**ADDENDUM
NO. 01**

July 31, 2024

Renovation of Fall Creek Intermediate School
12011 Olio Road
Fishers, IN 46038

DRAWING NO.
E4-1

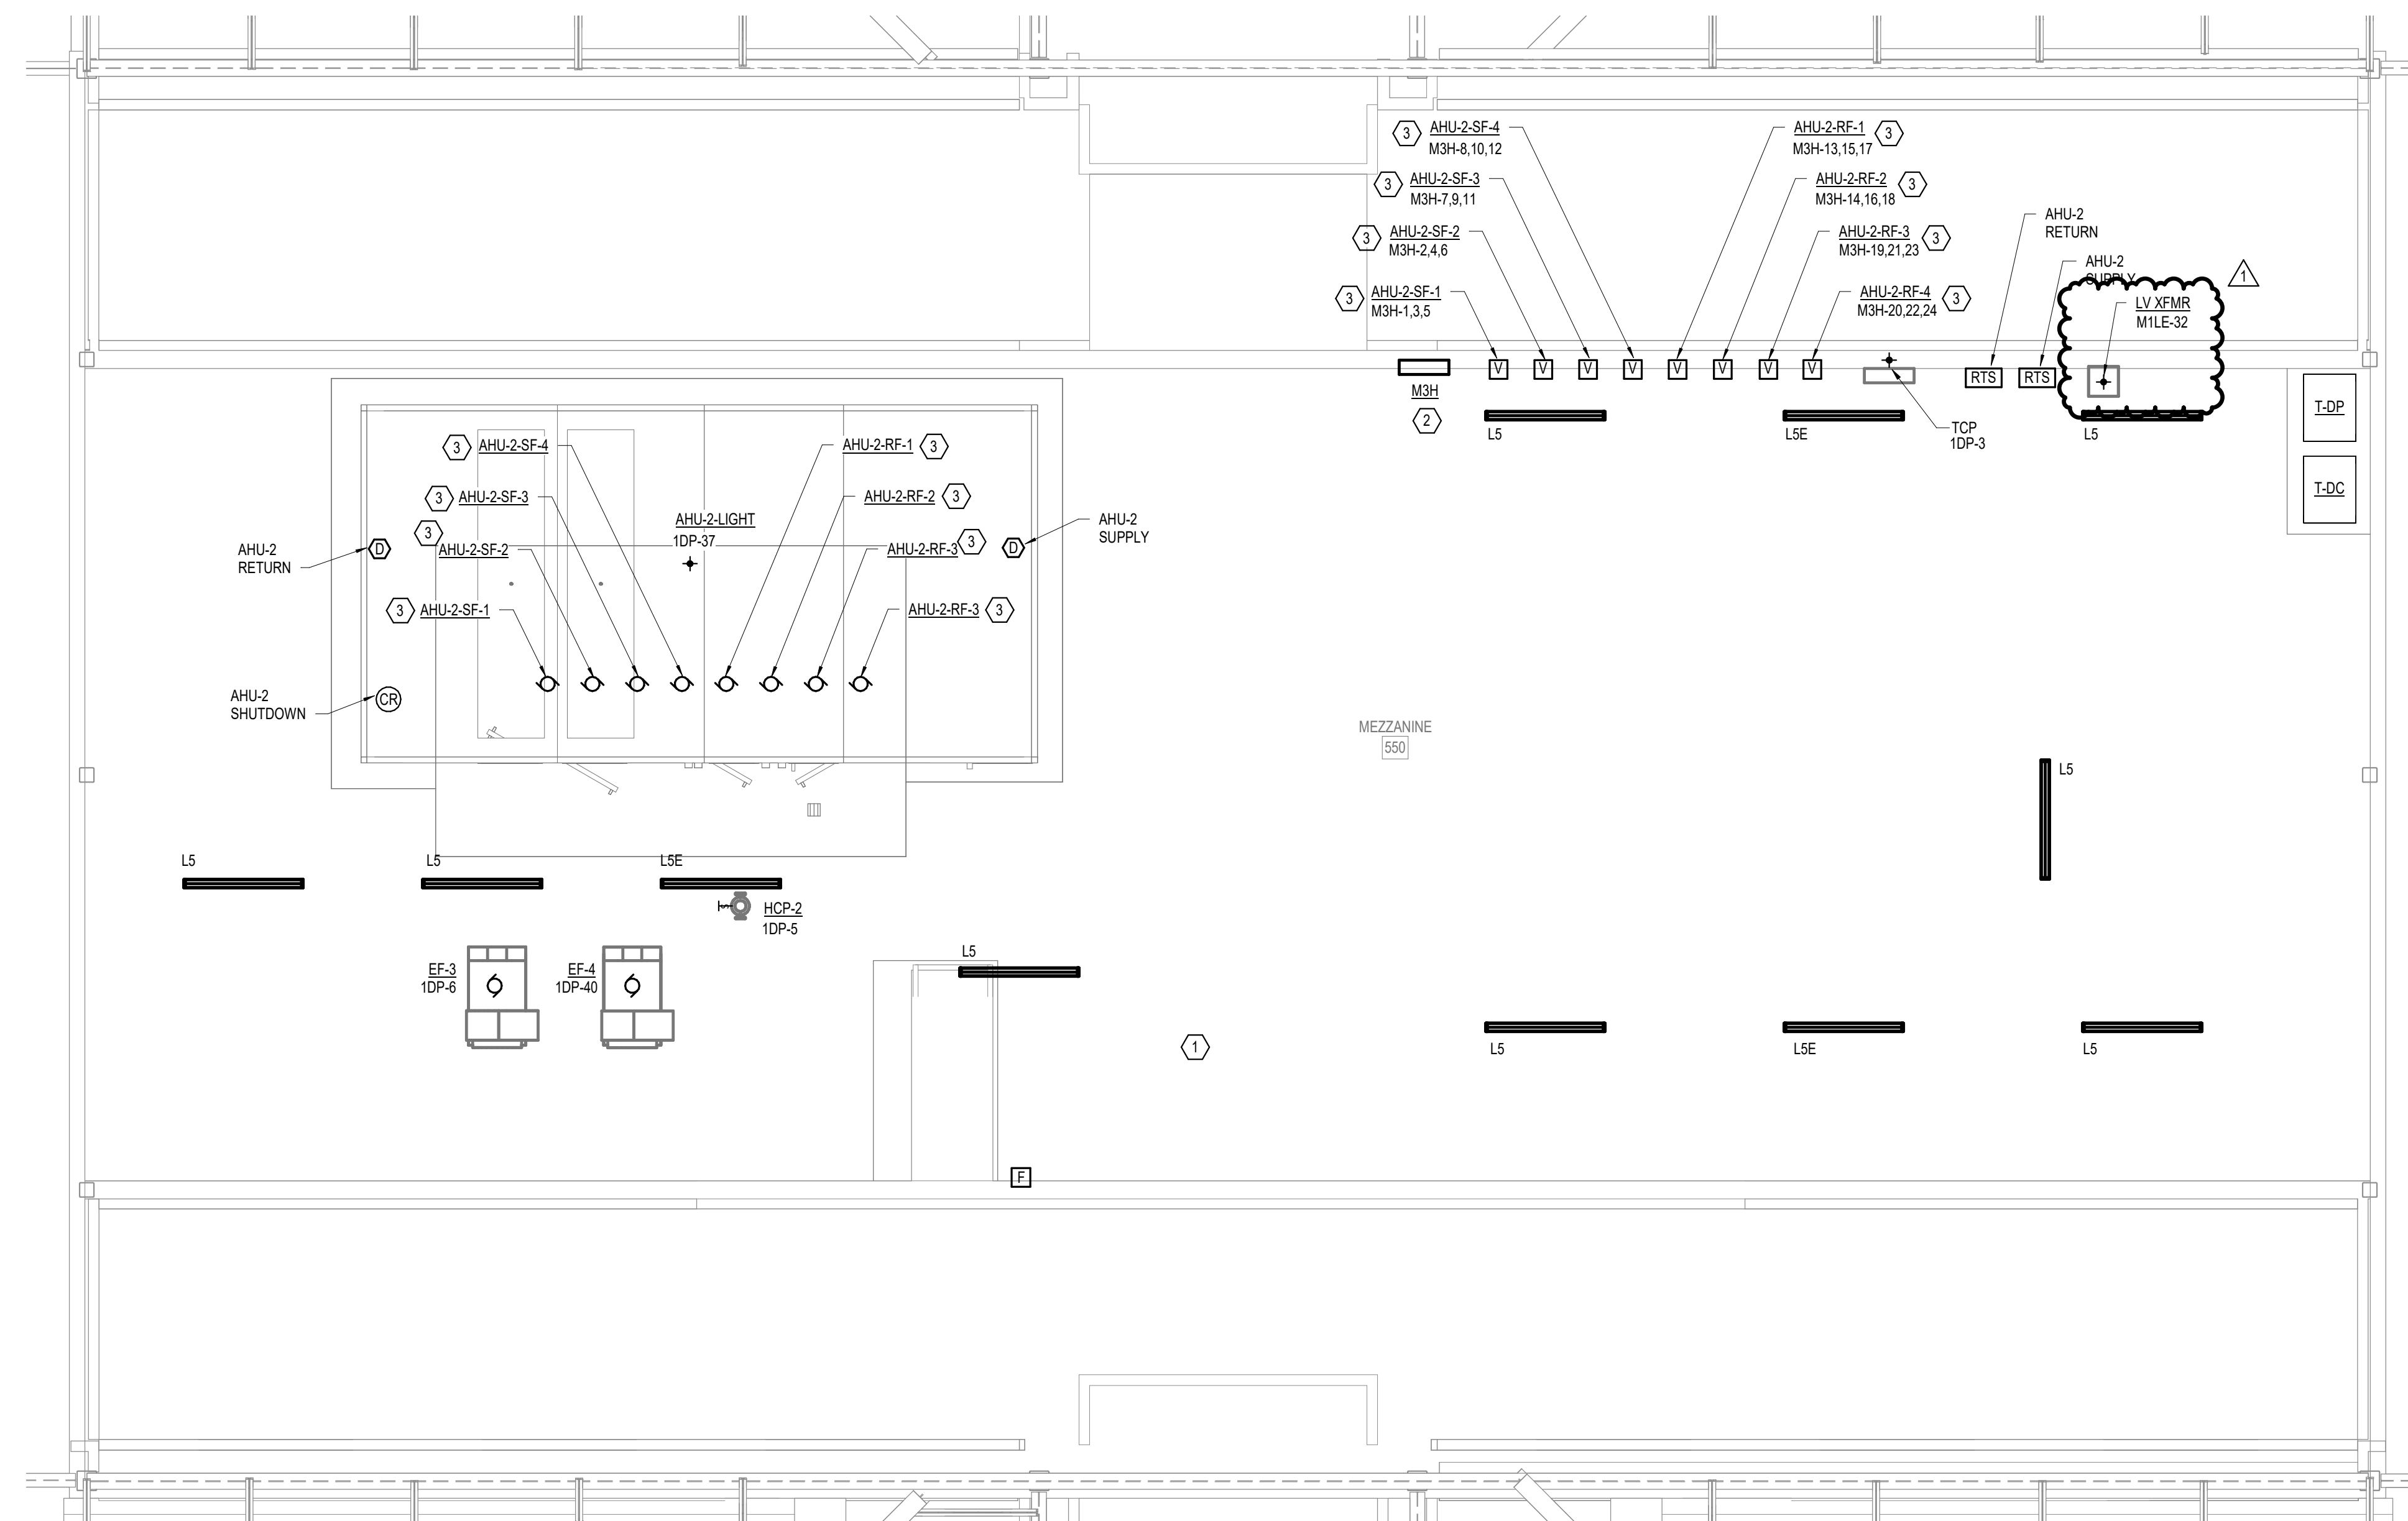
Sheet E4-1

1. Added electrical connection for new mechanical equipment.

2 NEW ELECTRICAL RISER DIAGRAM - MDP
NOT TO SCALE

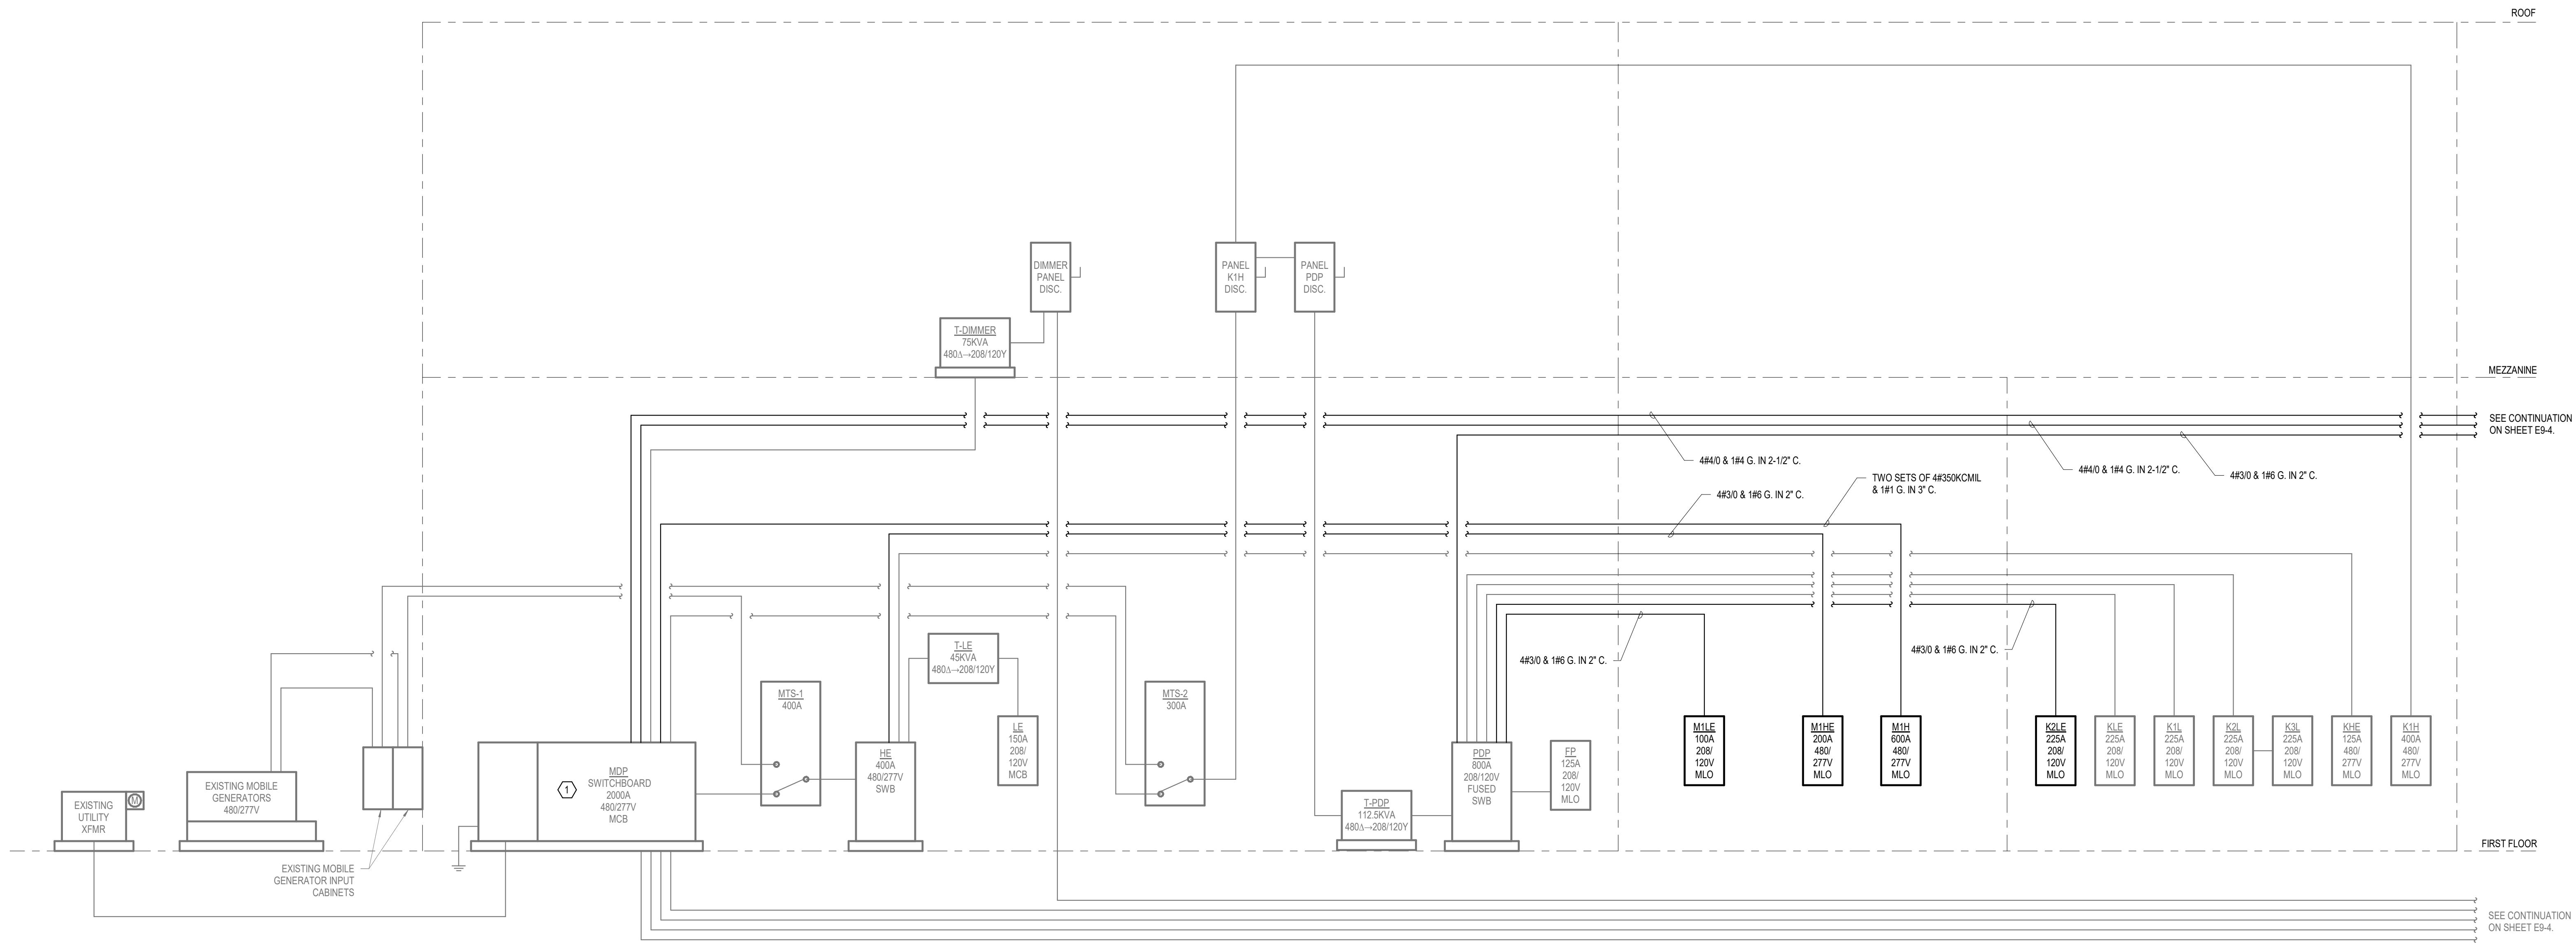
Sheet E9-3

1. Removed AHU-3 from New Electrical Riser Diagram - MDP. AHU-3 has been revised to be fed from panel M1HE.
